Windshield Wipers - Park in Vertical Position

Bulletin No.: 02-08-43-002

Windshield Wipers Park In Outwipe Position
(Install Wiper Motor Crank Arm and Wiper Motor Bracket Service Kit)

2002 Buick Century, Regal
2002 Chevrolet Impala, Monte Carlo
2002 Oldsmobile Intrigue
2002 Pontiac Grand Prix

Bent Wiper Motor Park Tab

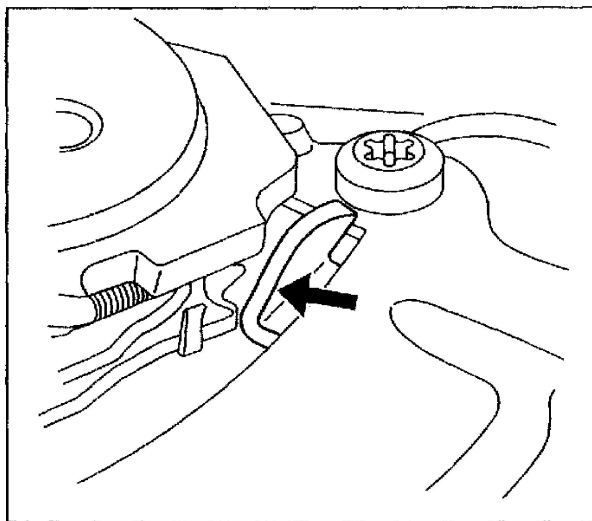
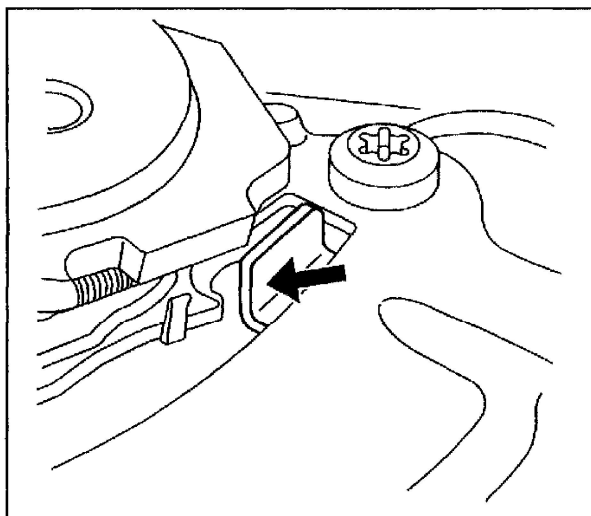
Some customers may comment that the windshield wipers park in the outwipe (vertical) position.

This condition may be caused by a bent park tab on the windshield wiper motor bracket.

1. Remove the windshield wiper motor drive system module. Inspect the park tab on the wiper motor bracket. It may be bent as shown in the illustration above. Refer to the Wiper Drive System Module Replacement procedure in the Wipers/Washer Systems sub-section of the Service Manual (SI Document ID # 818798).
2. Remove the windshield wiper transmission from the windshield wiper motor bracket. Refer to the Wiper Transmission Replacement procedure in the Wipers/Washer Systems sub-section of the Service Manual (SI Document ID # 818797).
3. Remove the windshield wiper motor crank arm from the windshield wiper motor. Refer to the Wiper Motor Crank Arm Replacement procedure in the Wipers/Washer Systems sub-section of the Service Manual (SI Document ID # 818984).
4. Remove the windshield wiper motor from the windshield wiper motor bracket. Refer to the Wiper Motor Replacement procedure in the

To correct this condition, install a new windshield wiper motor crank arm and a windshield wiper motor bracket service kit. Use the following service procedure:

5. Reassemble the windshield wiper motor drive system using a new windshield wiper motor crank arm, P/N 12494832 and the contents of the windshield wiper motor bracket service kit, P/N 88958149 (in Canada, P/N 88958260). The park tab on the new wiper motor bracket should be straight as shown in the illustration shown above.
